Addendum No. 3

**Post Point Sludge Tank Replacement Project
City Project No.: EU194
Bid Number: 3B-2026**

October 15, 2026

DRAWING NO.	440M104
SHEET NO.	74 OF 198

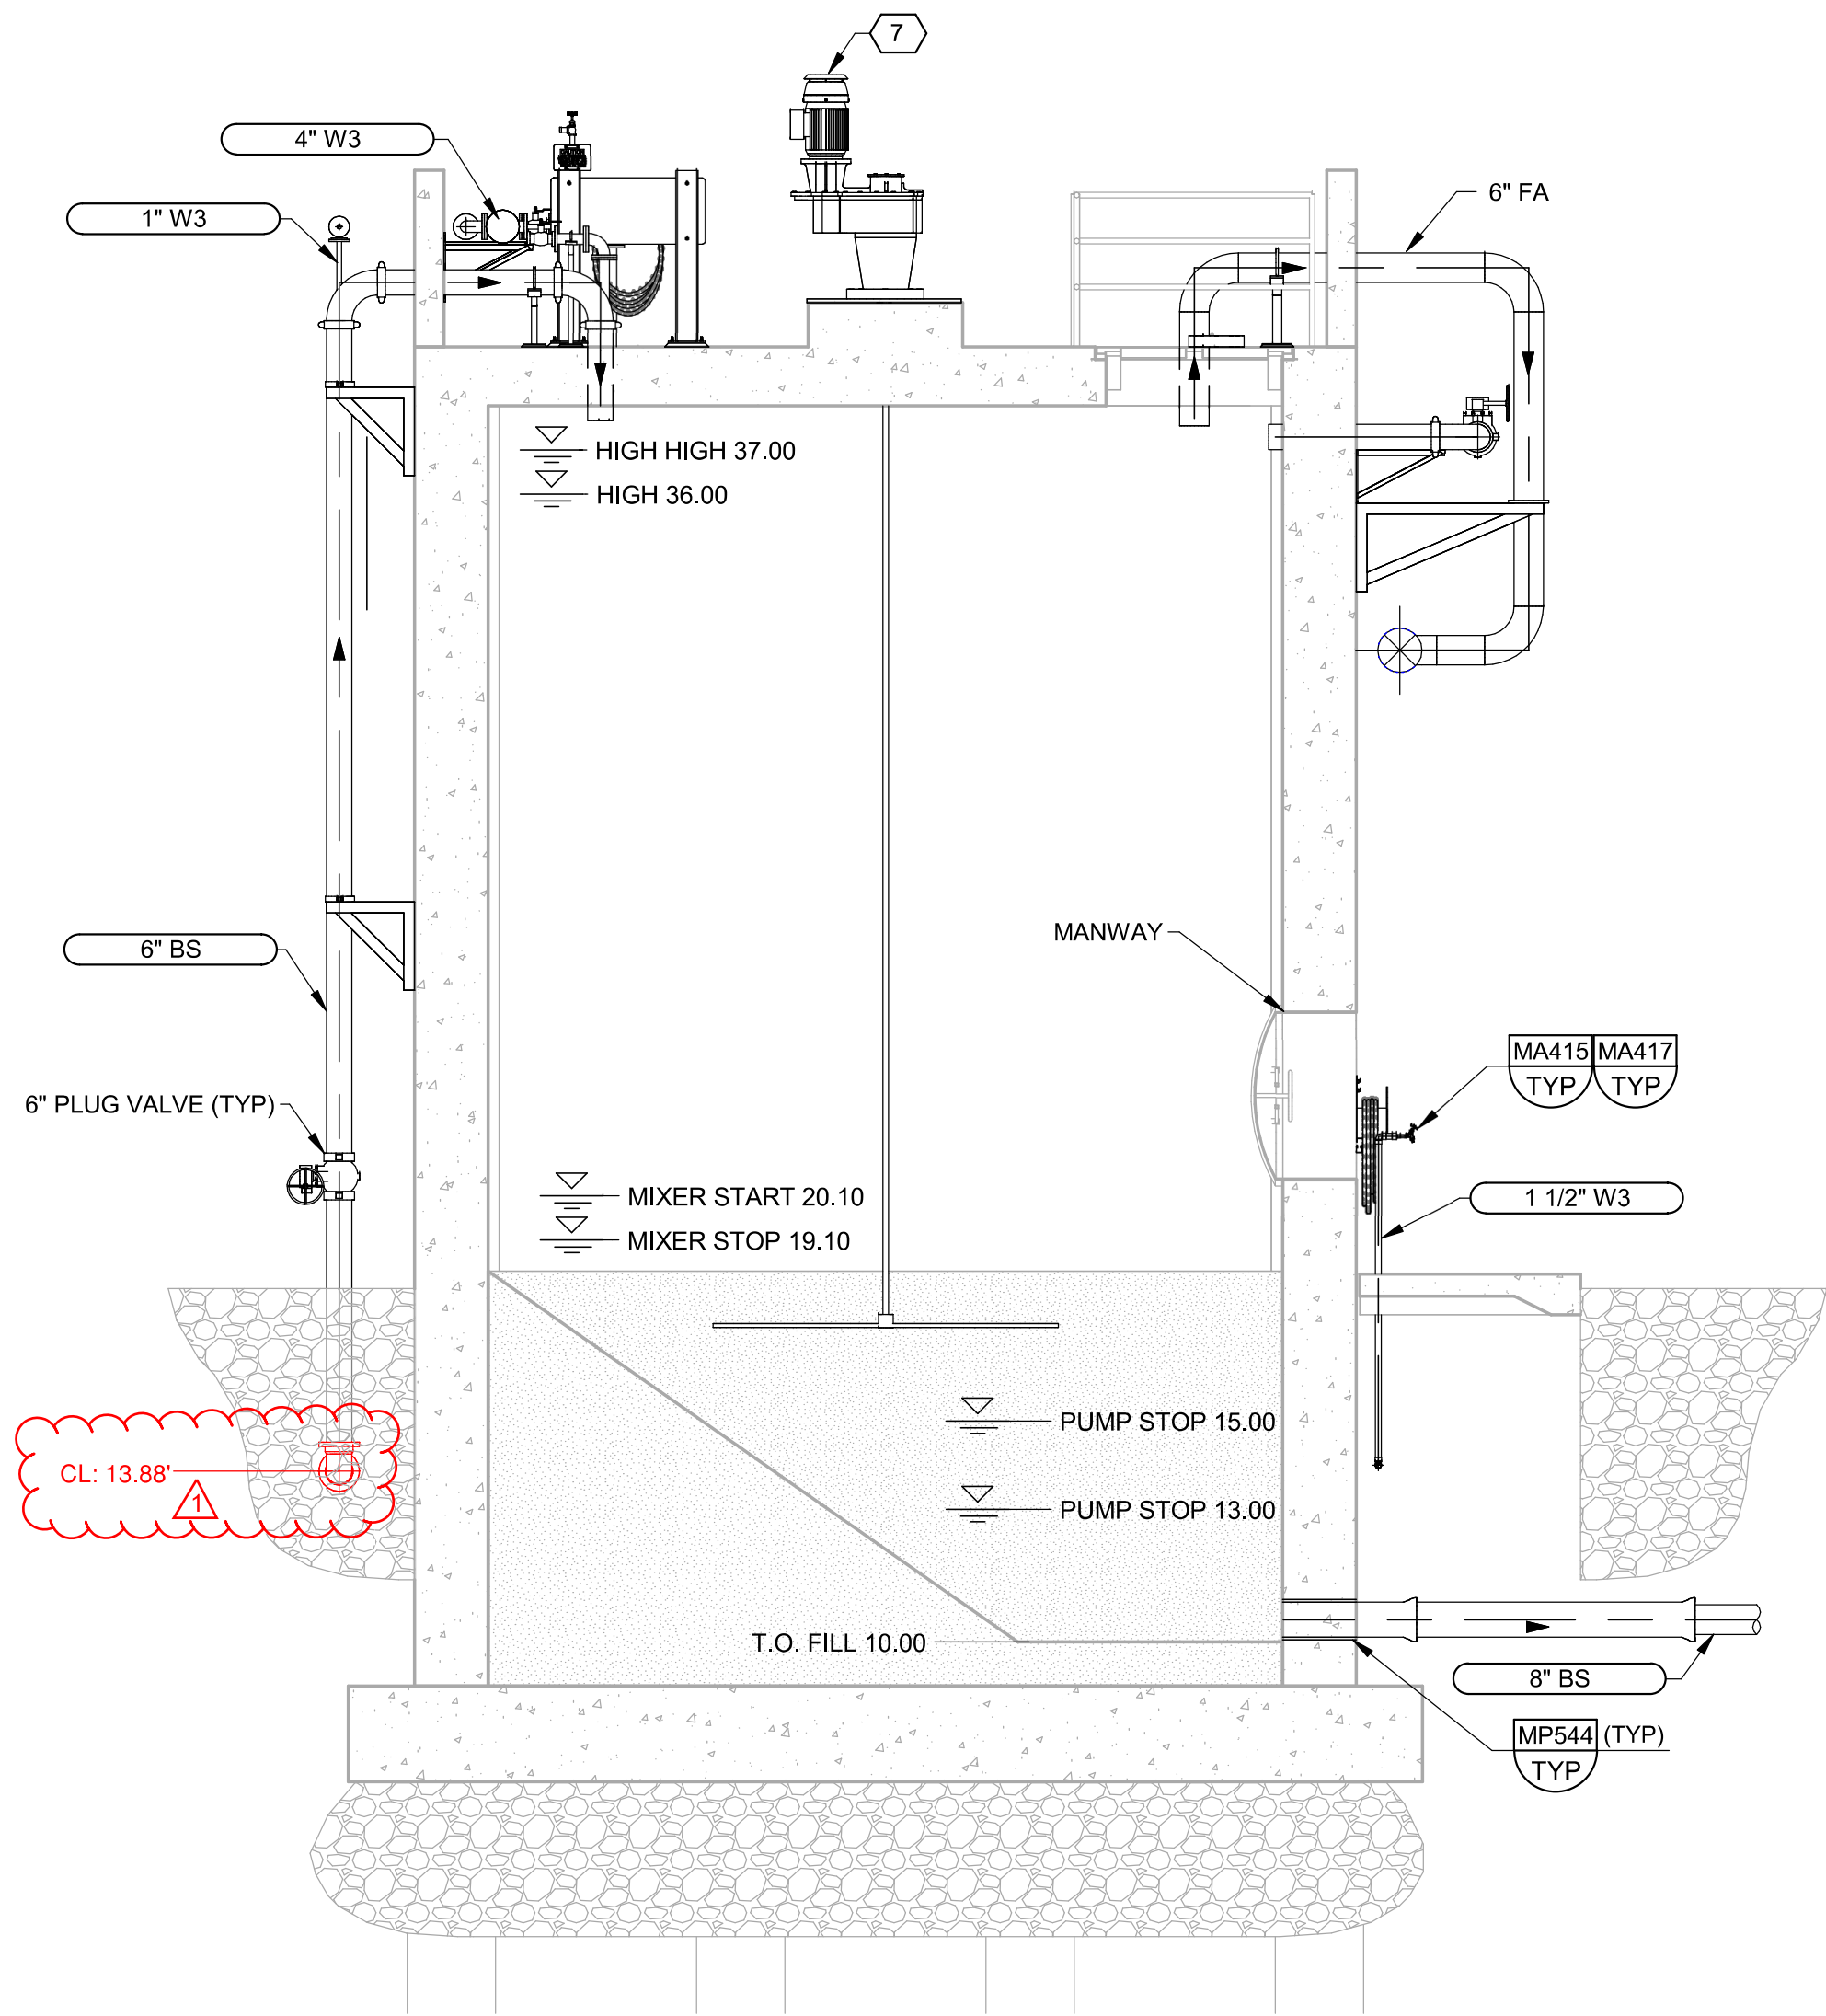
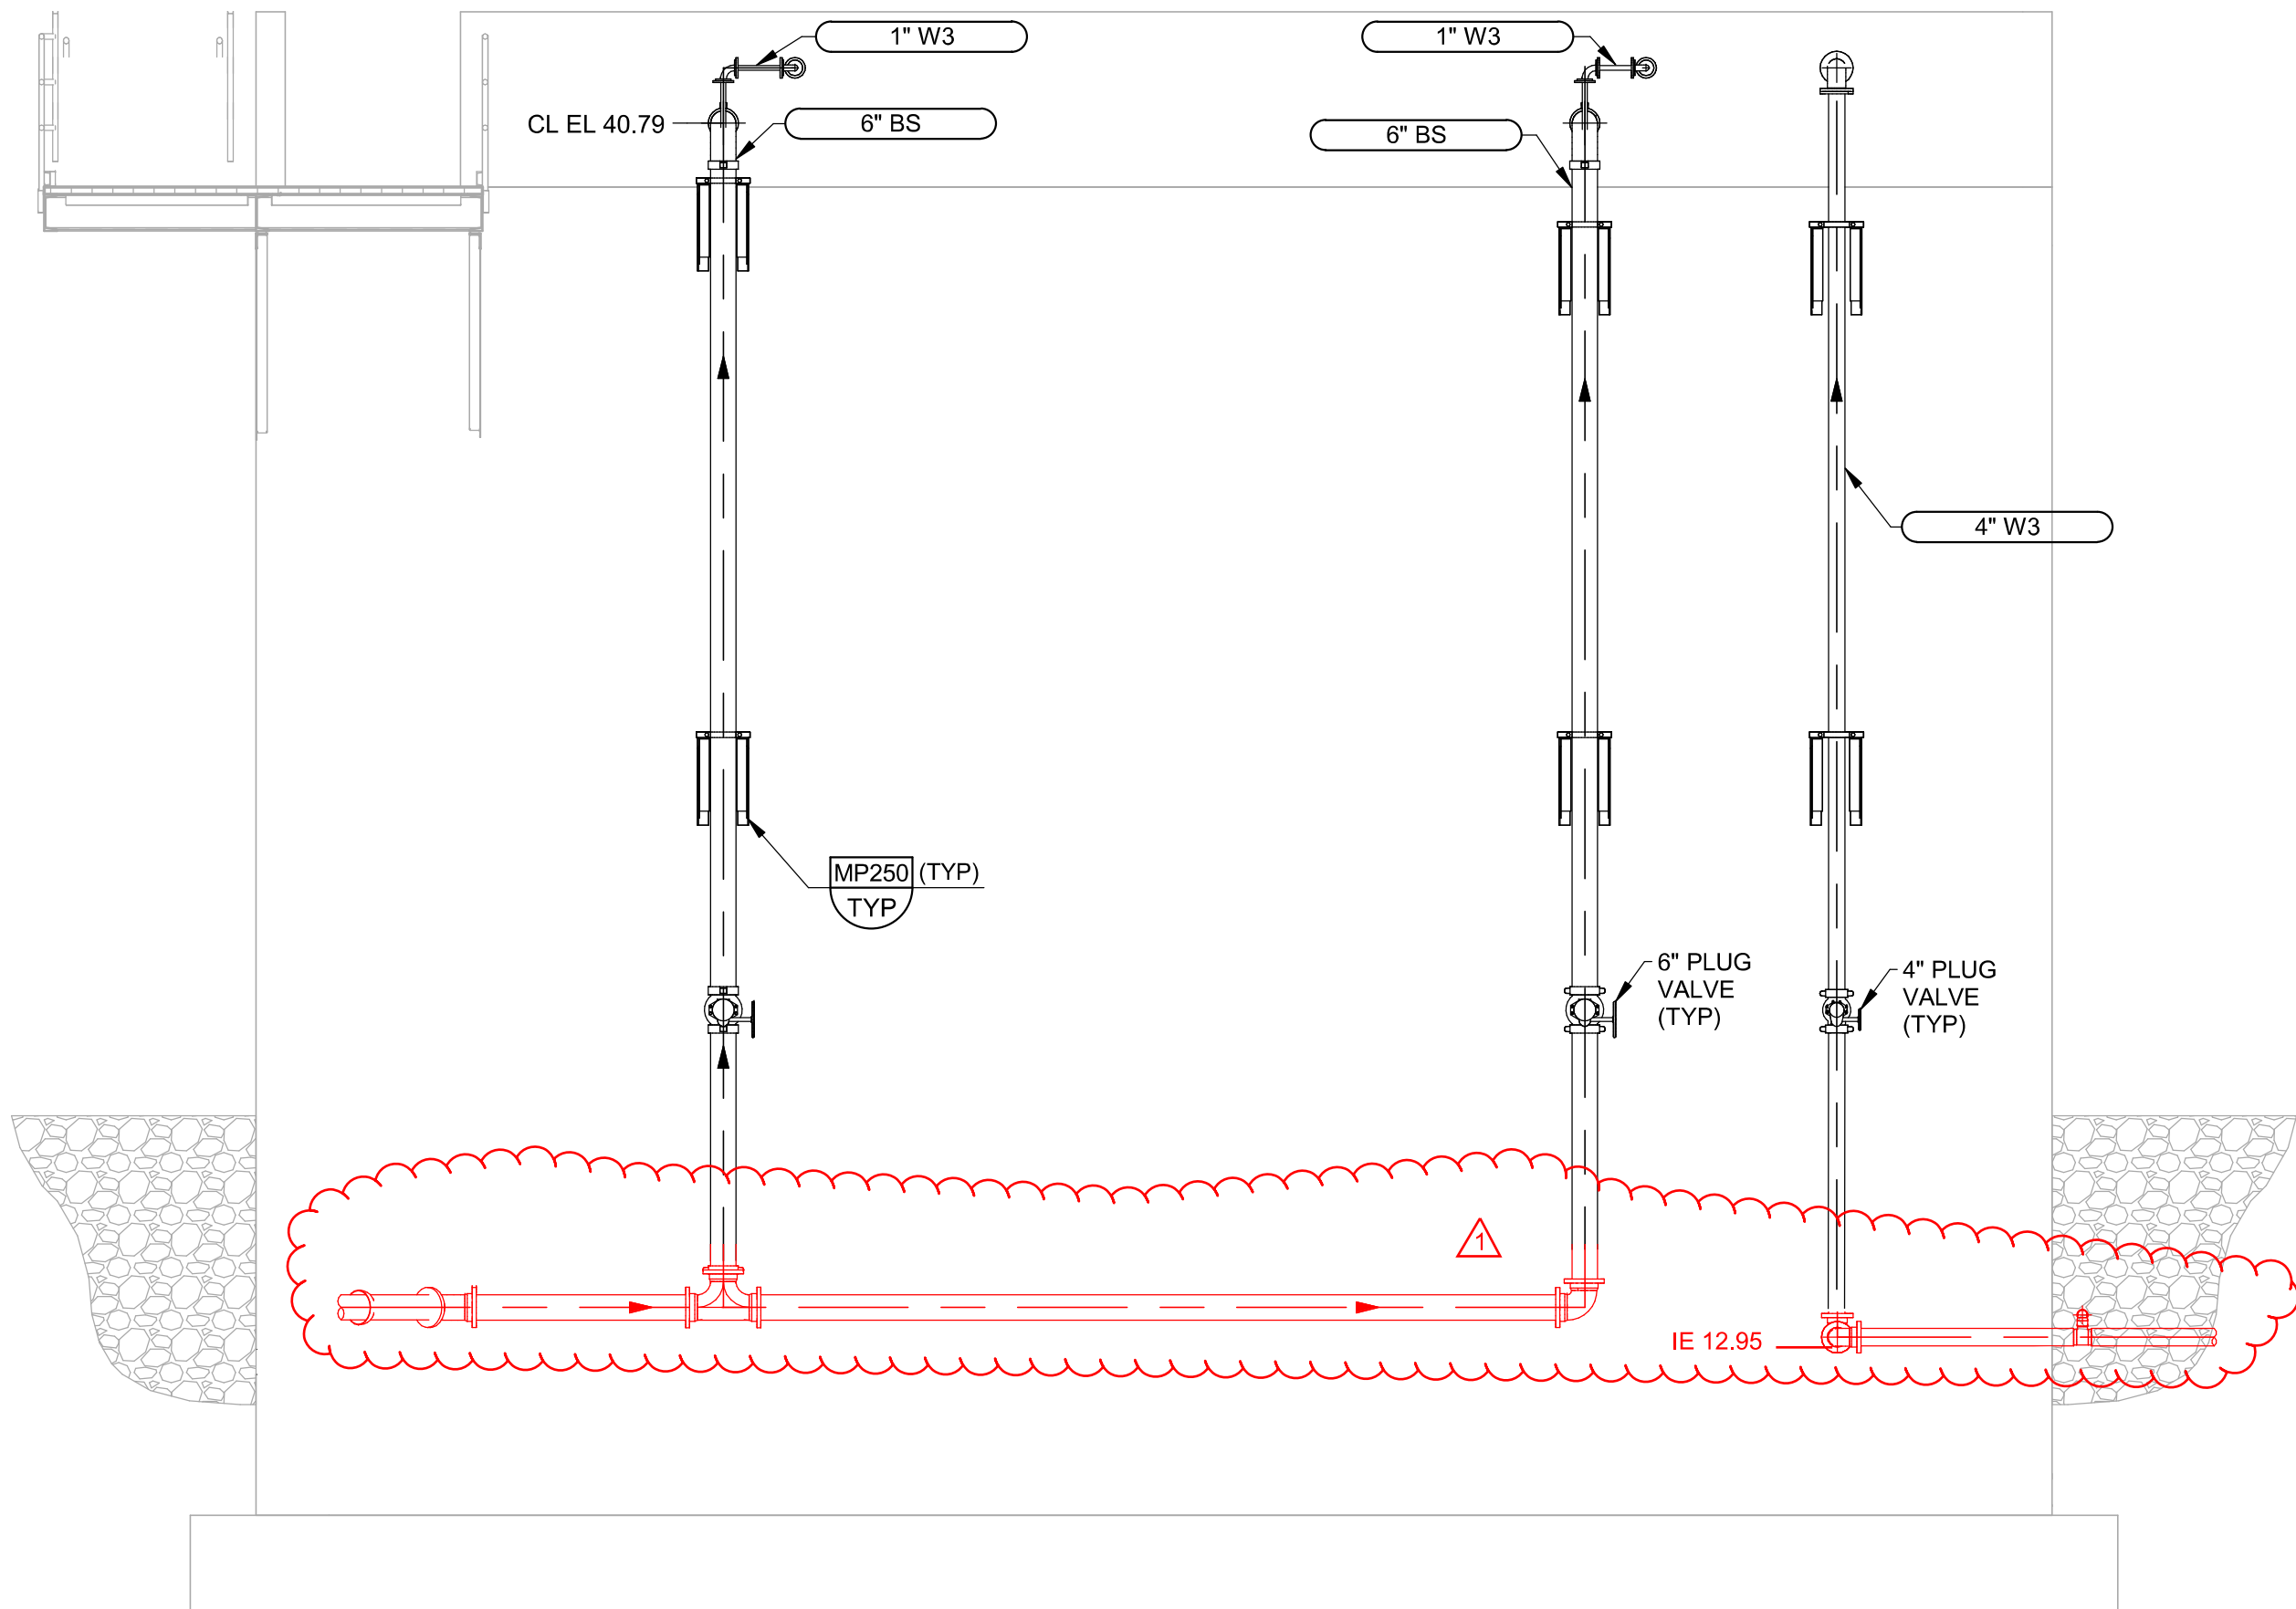
- 6. Drawing 440M104 – SLUDGE STORAGE TANKS SECTIONS 2
 - a. **DELETE** and **REPLACE** in its entirety. Drawing provided as Attachment A in this Addendum.

- c. The mechanical drawings show the 6-inch BS at centerline elevation 12.60 at the gallery (050M104, Section G), 15.80 inside Sludge Storage Building 420 (420M102, Section D) and 12.50 at the tanks (440M104, Section E). Please confirm these are the elevations at the wall penetrations and that the buried pipe runs at uniform slope between them.

Response: See Attachment A for clarification on the elevations. Continuous slope between the points is required. For pressurized pipes, the Contractor can install elbows to adjust elevation as needed to accommodate yard interferences insofar

DRAWING NO. 420H101
SHEET NO. 82 OF 198

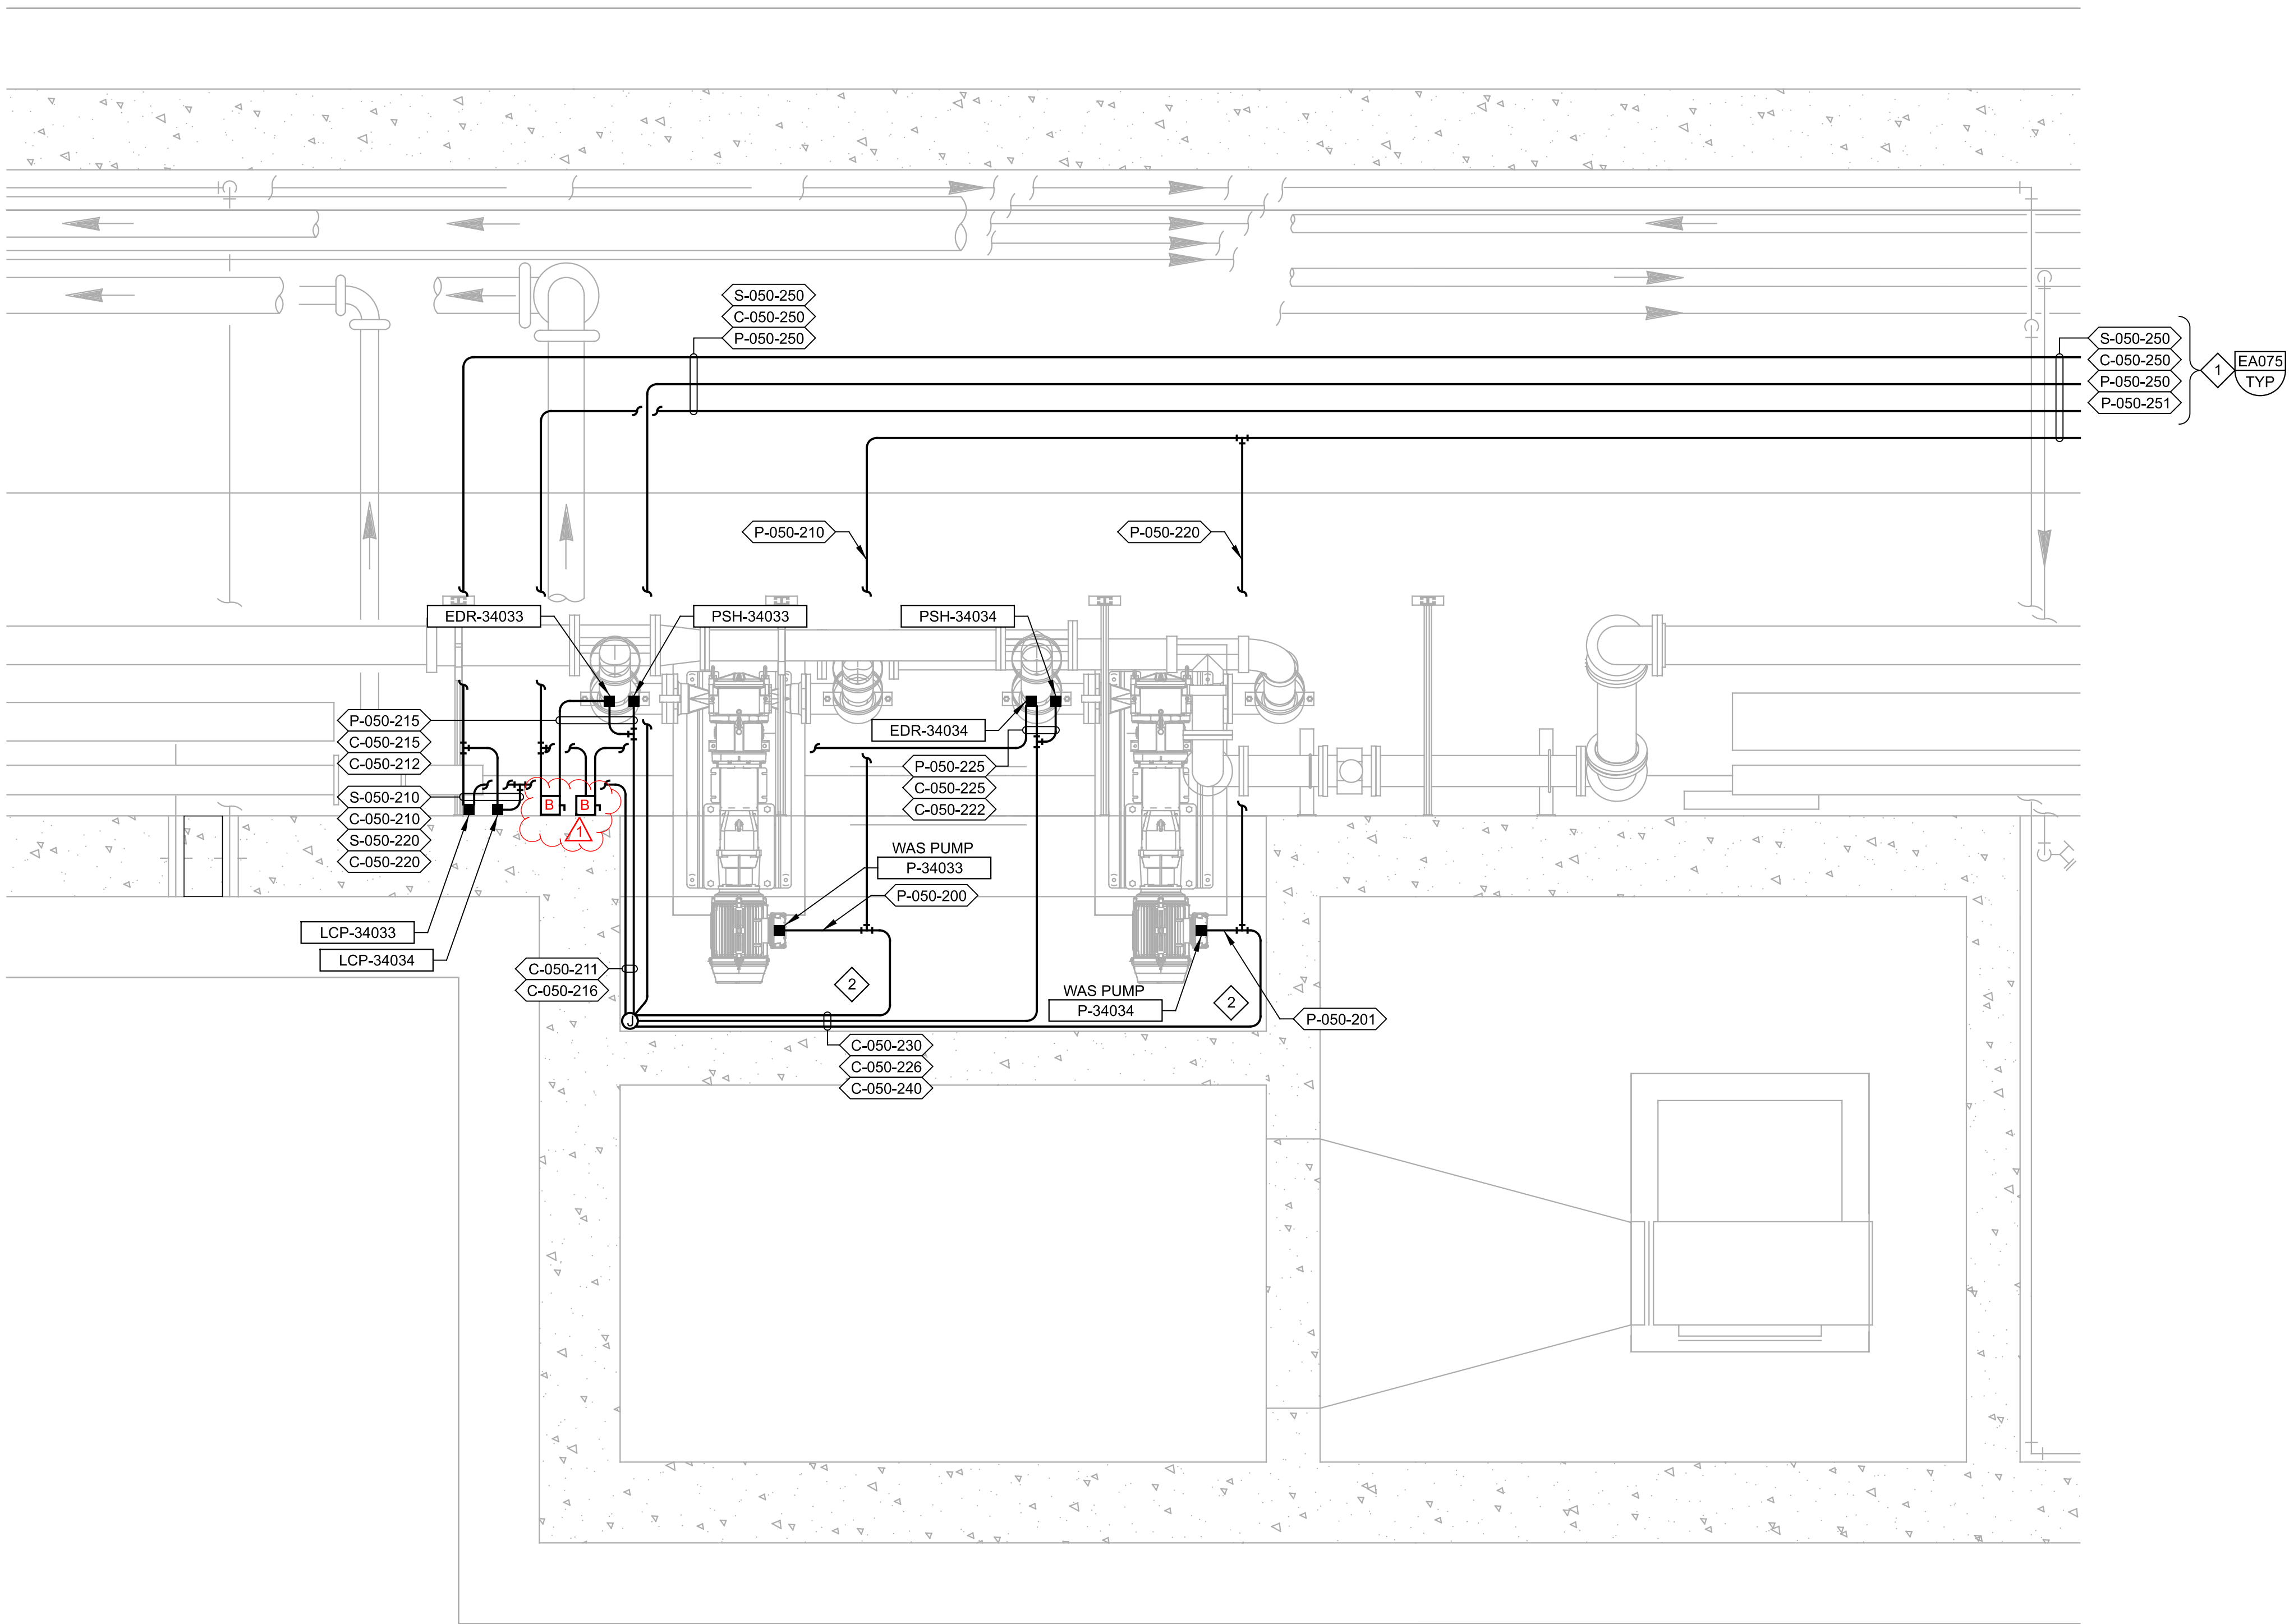
- 4. Drawing 420H101 – SLUDGE STORAGE BUILDING BASEMENT PLAN
 - a. **DELETE** and **REPLACE** in its entirety. Drawing provided as Attachment A in this Addendum.

Response: See Attachment A for replaced Drawing 420H101 that shows the thermostat location.
